**PIERGIORGIO BERUTO**  
**ANTONIO ORZELLI**

*IEEE 802.3cg*  
PLCA Burst mode  
*October 24<sup>th</sup>, 2018*

Figure 148-4—PLCA Control state diagram (continued)

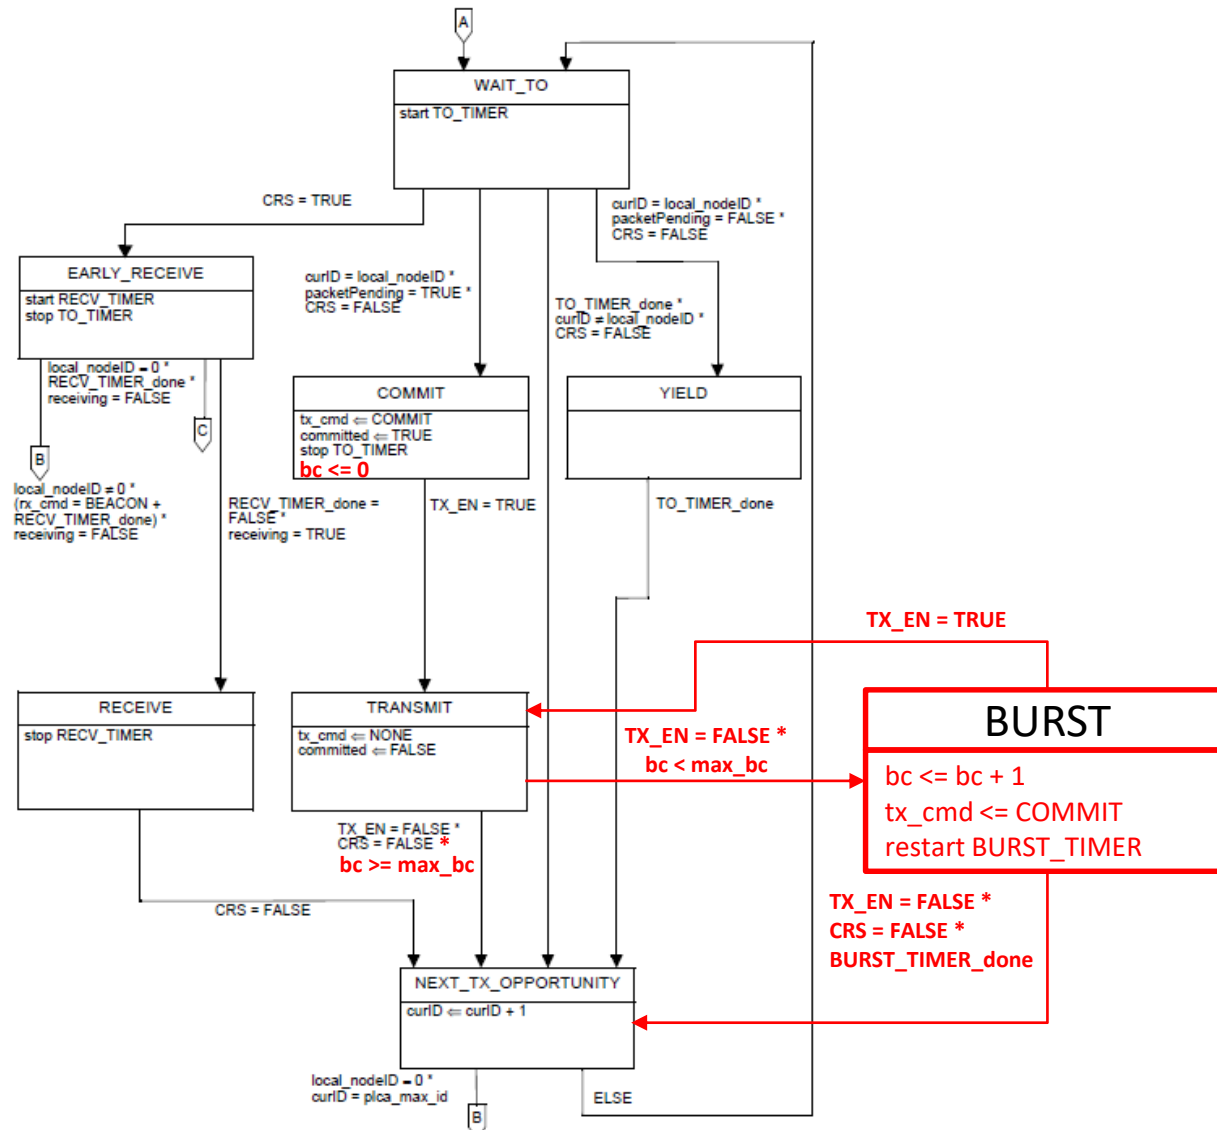
# Changes to State Diagrams

- $bc$  = counts the number of packets currently sent in a burst after the first transmission  
Value: integer from 0 to 255
- $max\_bc$  = maximum number of packet the node is allowed to transmit in a single burst after the first transmission. Set by management via MDIO register TBD.  
Value: integer from 0 to 255
- BURST\_TIMER counts the time to wait for the MAC to send a new packet before yielding the transmit opportunity. This timer can be set via MDIO register TBD. For PLCA Burst mode to work properly this timer needs to be greater than one IPG period.

- BURST\_TIMER have to be set large enough to allow the local MAC to transmit a new packet
  - Assuming the MAC is capable of transmitting packets back-to-back, BURST\_TIMER have to be at least 96 bits (one IPG at 10Mb/s operation) + some margin
  - BURST\_TIMER needs not be configured equal across all nodes
  - Increasing BURST\_TIMER relaxes time requirements on the MAC at the expense of throughput.
- Throughput is not significantly affected by burst mode
  - Worst case scenario is when the BUS is at max load, every node send the smallest allowed packet (72 bytes) and all are allowed to burst.
    - In this case the throughput penalty is one IPG per node.
      - That is,  $1 - (72 * 8 + 96) / (72 * 8 + 96 * 2) = 12.5 \%$
